# COMBINED LINWOOD/EASTERN INTERCHANGE & US 50/RED BANK INTERCHANGE FOCUS AREA ADVISORY COMMITTEE MEETING NOTES

EASTERN CORRIDOR SEGMENTS II AND III (PID 86462)

## MEETING #3 NOTES

Sept. 7, 2018

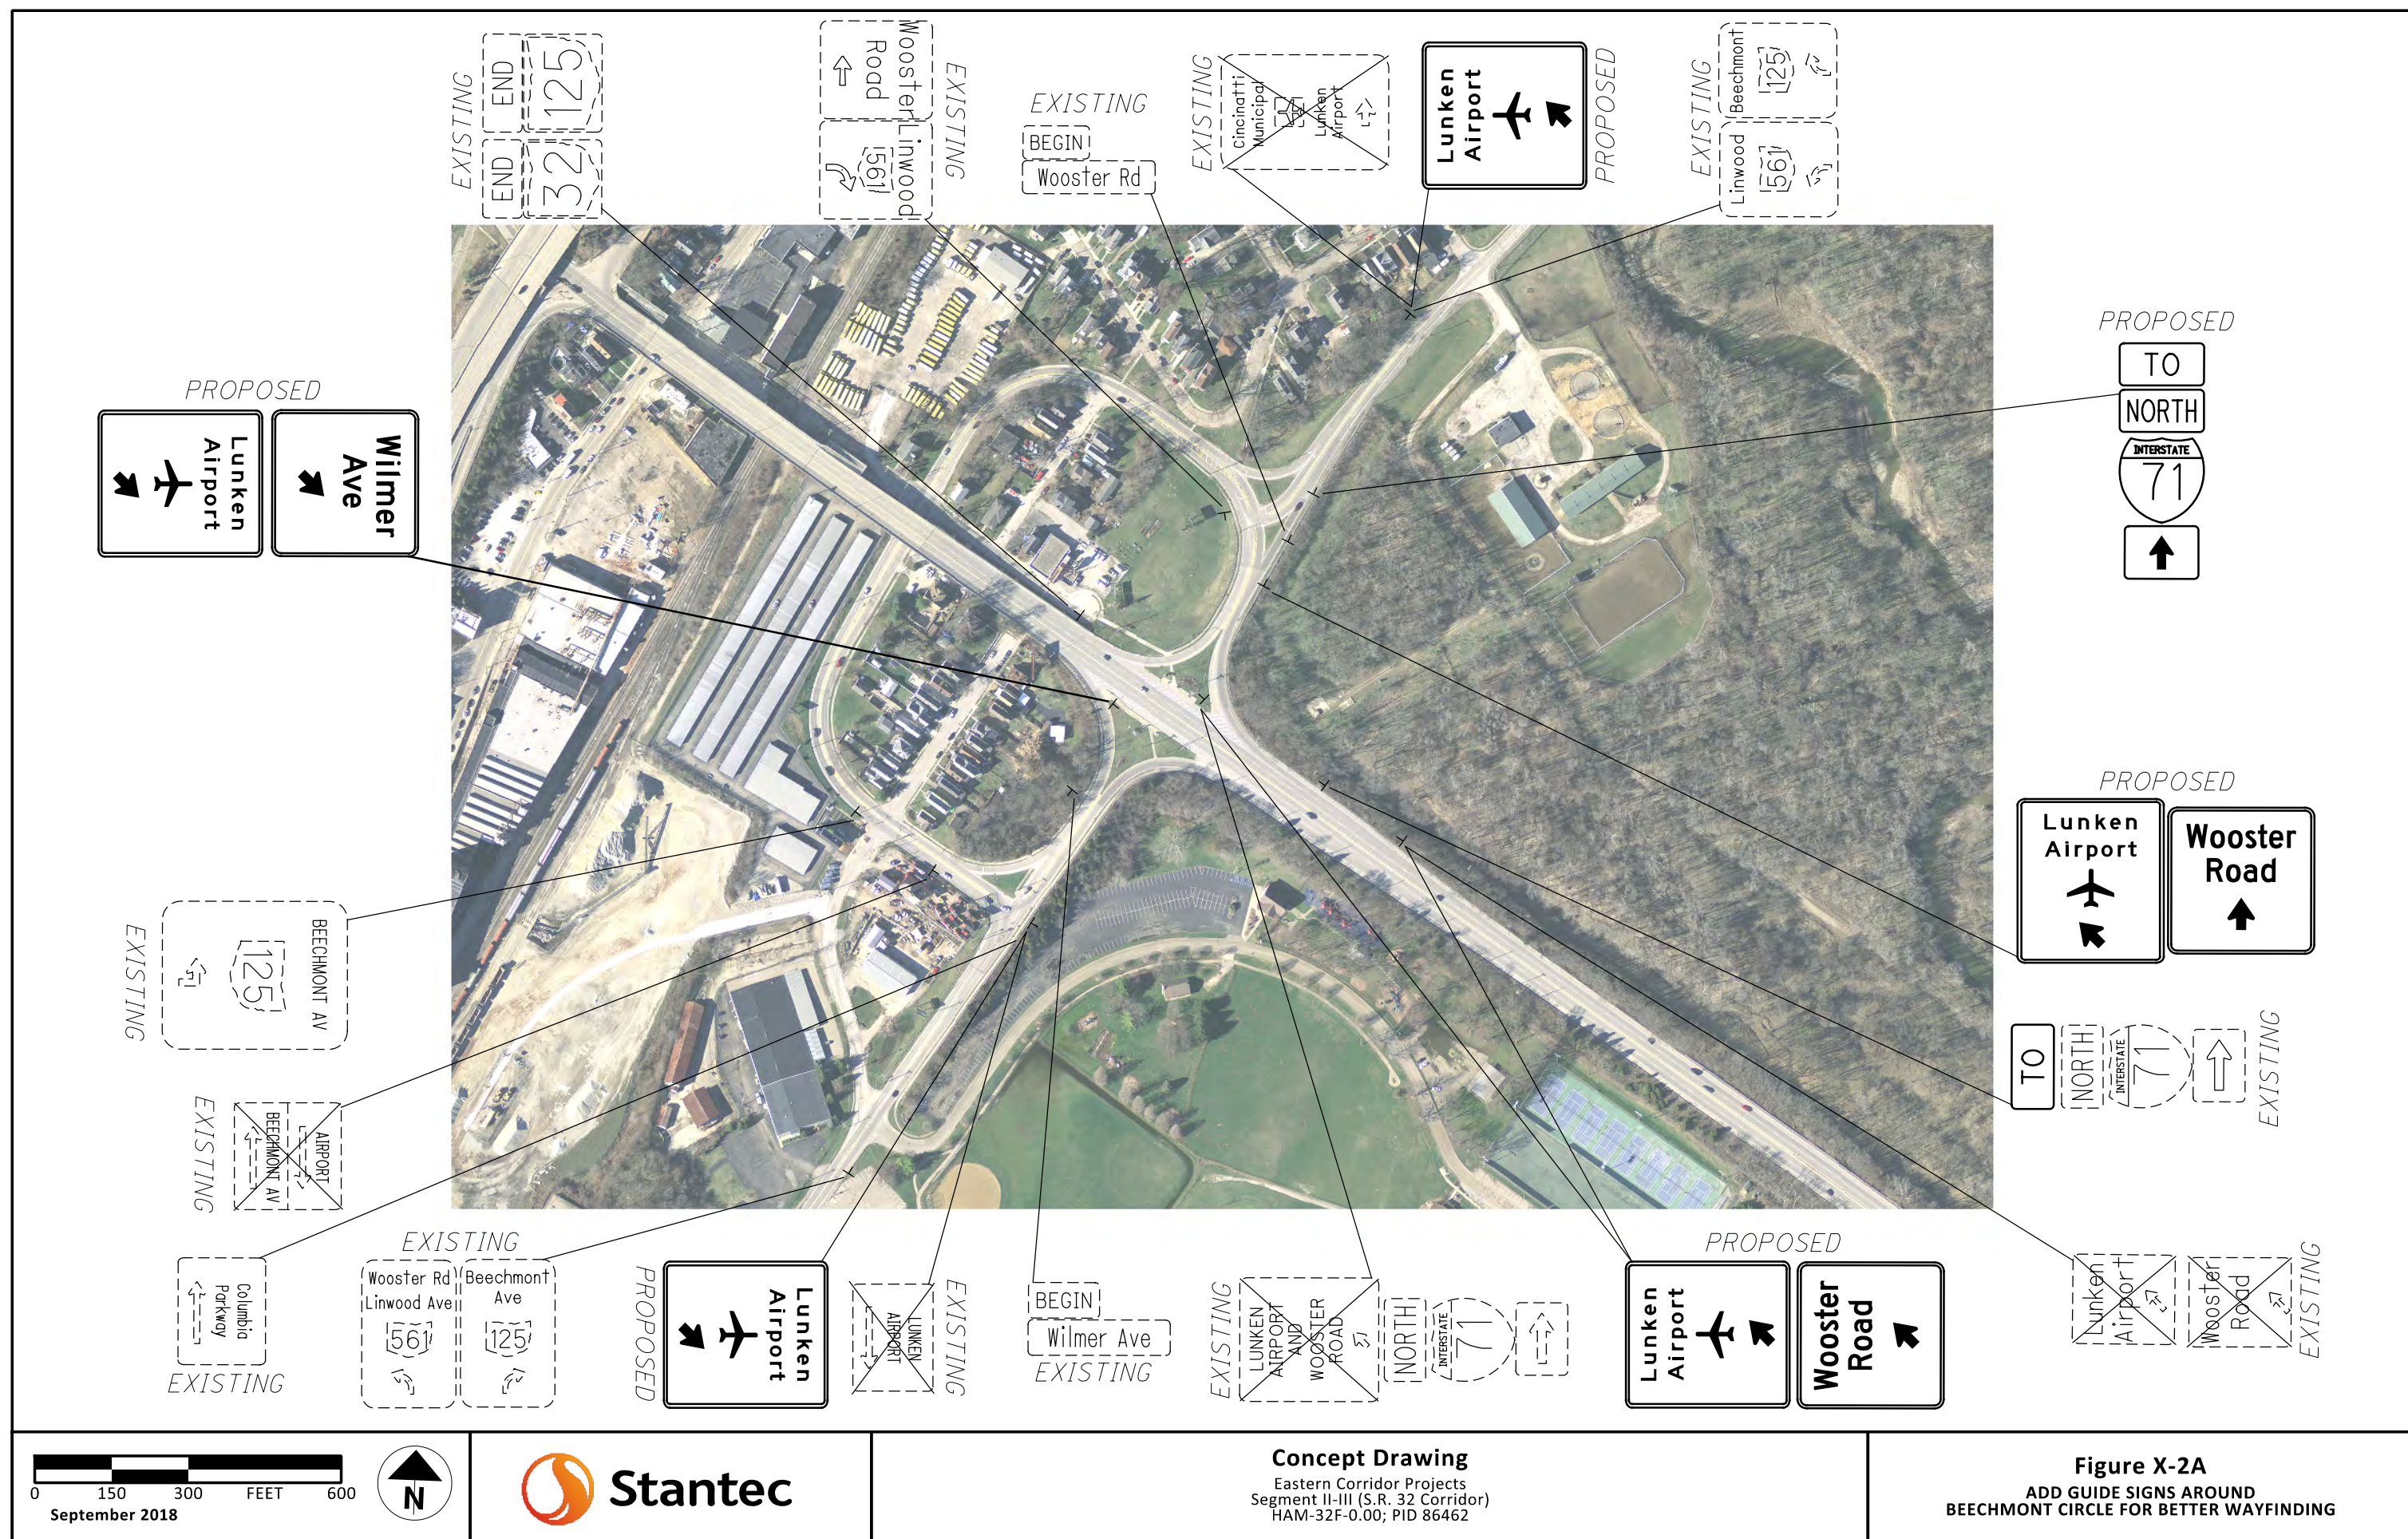
- While there are a variety of signs in the area, there is not a lot of consistency regarding how the signs look, particularly in terms of Lunken Airport signage.

- Proposed new signs are shown in bold on the concept exhibit; signs recommended for removal are drawn with an "X" through them.
- The Committee suggested that the signs be shown in color for the public meeting.

- One Committee member requested making it more obvious to drivers turning onto Wooster from the Beechmont Circle that they have the right-of-way; many think they must yield to drivers coming off of the Beechmont Levee. Others agree that it would be an improvement to add signage to more clearly define who has the right-of-way at this location.

- The best way to address the confusion regarding driver right-of-way at the Beechmont Circle/Wooster location is to add a second lane (see I-26b). This could be accomplished by expanding onto the shoulder and removing the median on Wooster.

- Advance for public consideration.

**Figure I-26B**  
**CONTINUOUS RIGHT TURN LANE FROM  
BEECHMONT CIRCLE TO WOOSTER ROAD**

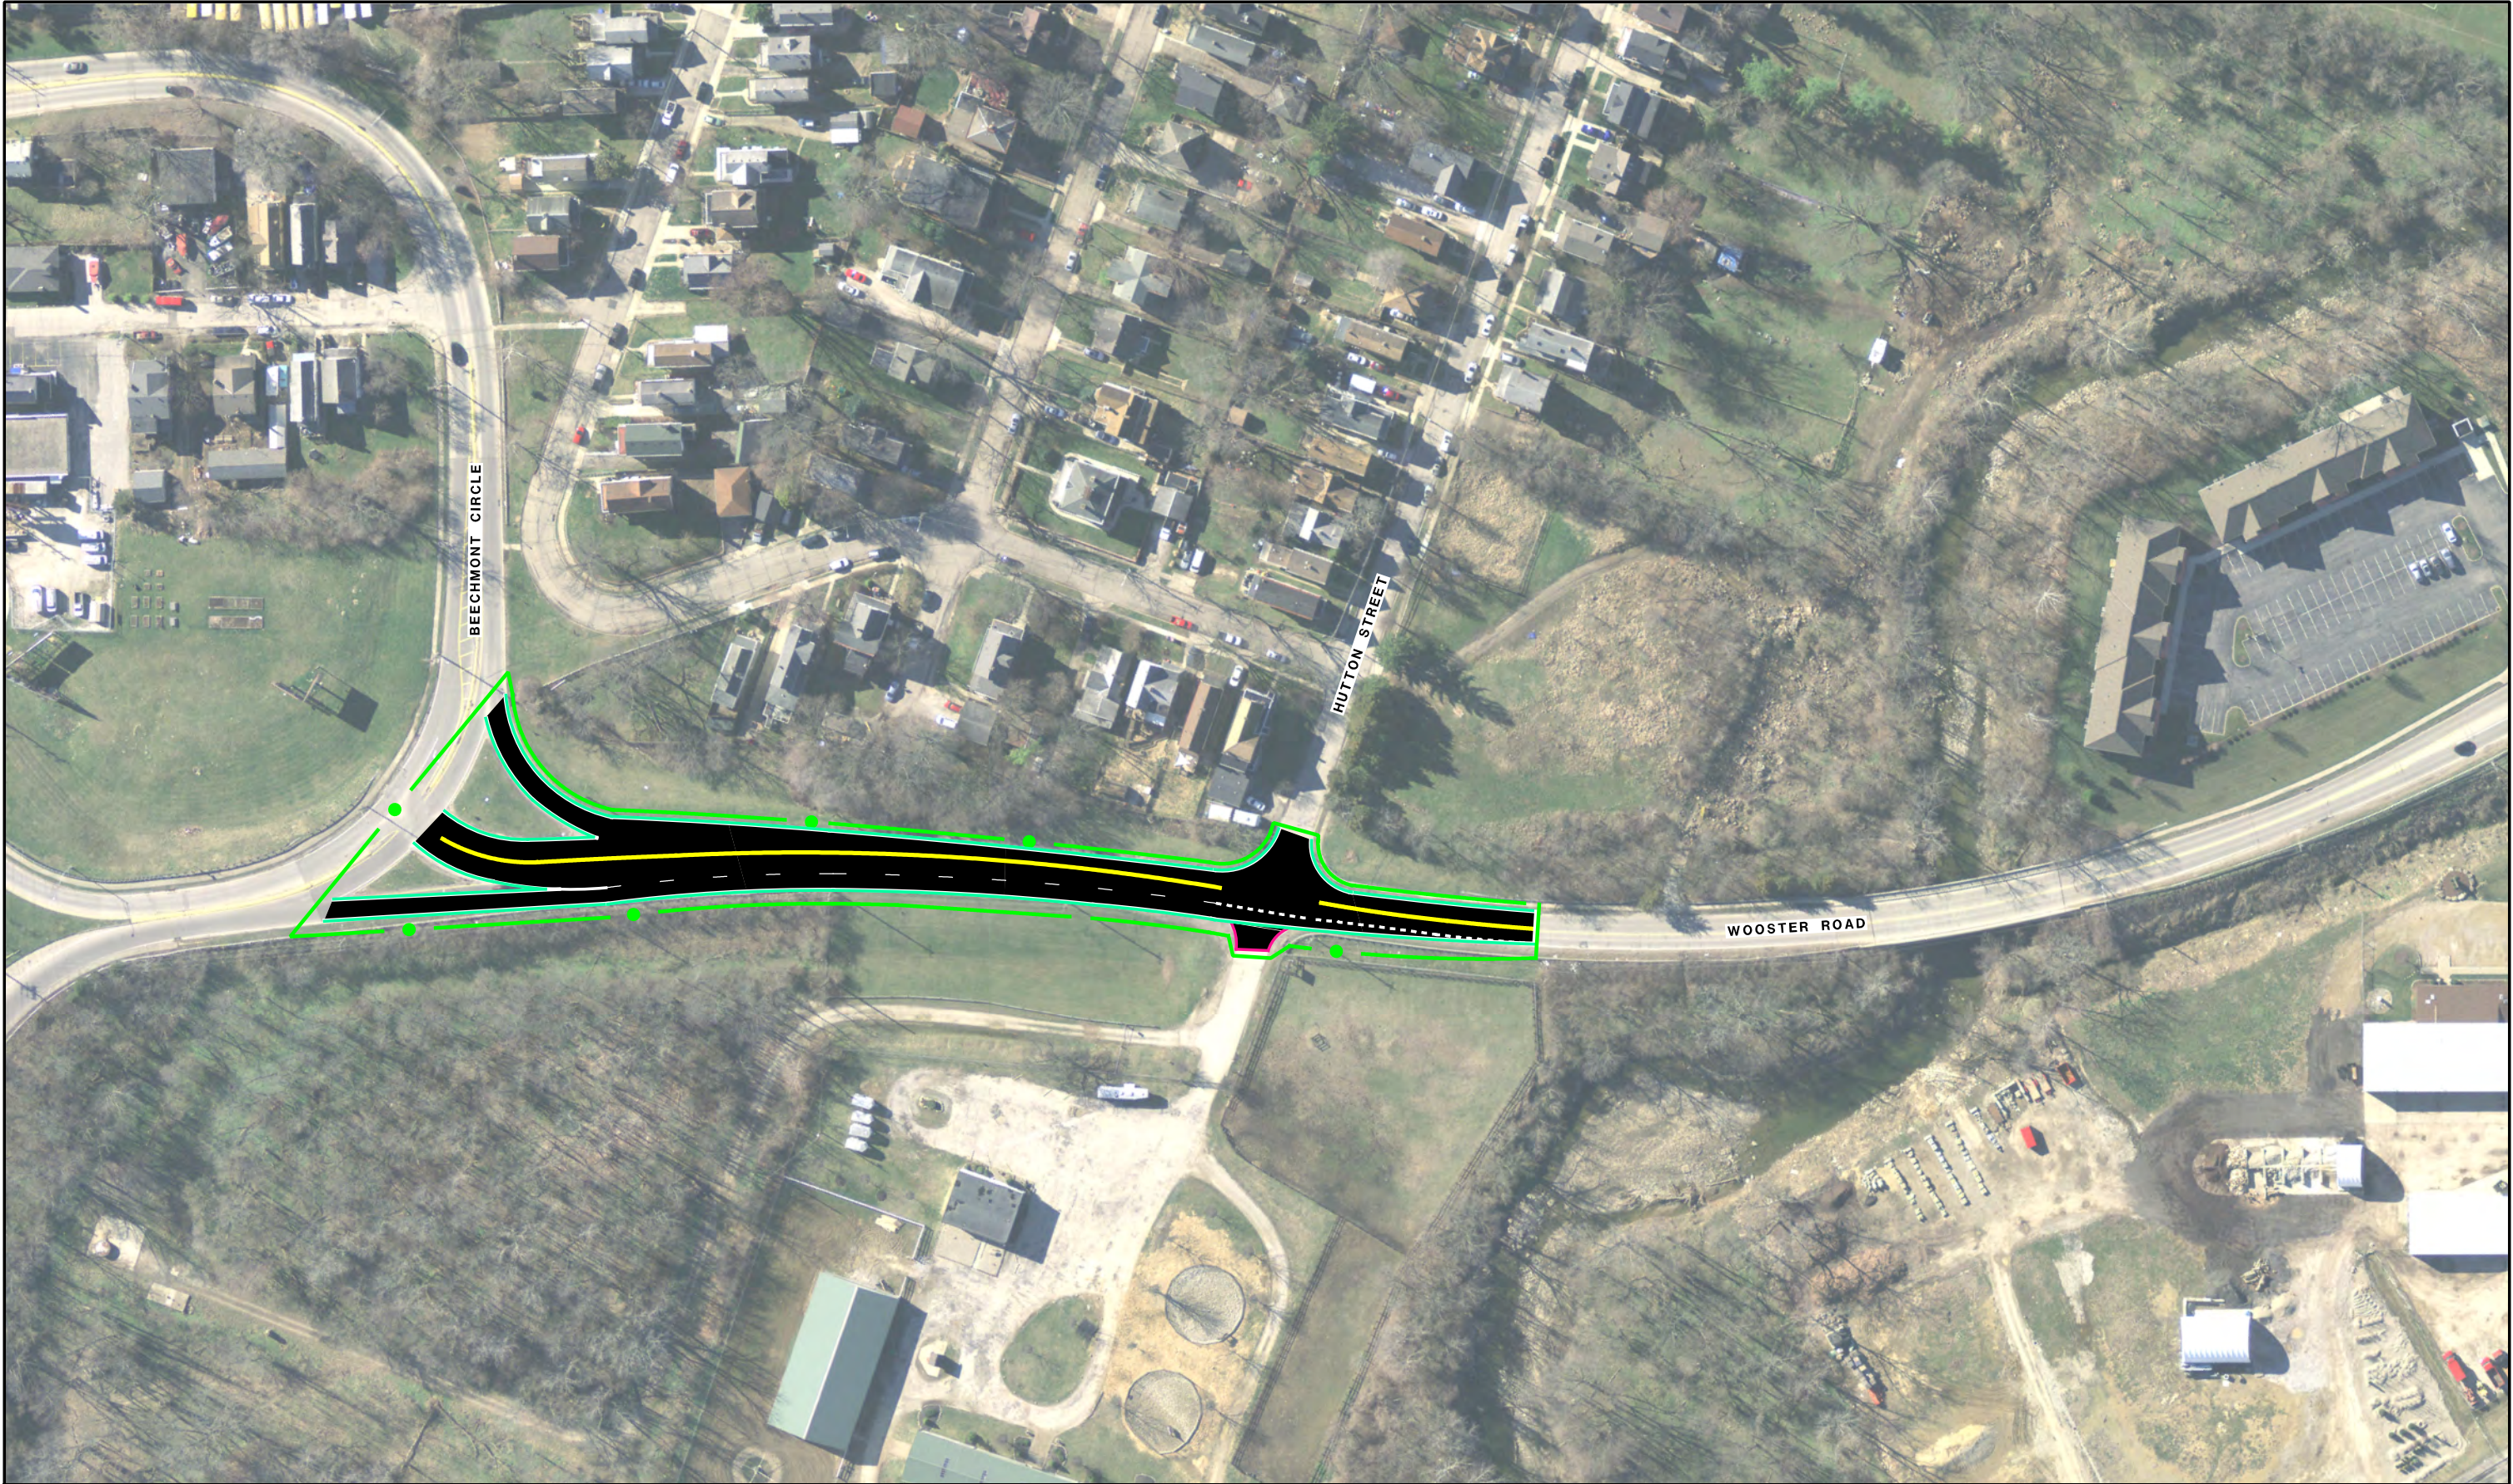
- Concept removes the median on Wooster to allow for two lanes. This creates a continuous right turn lane at Beechmont Circle for turns onto Wooster from SR 125, so those drivers can merge instead of coming to a yield line. The concept includes minimal widening.

- Advance for public consideration.
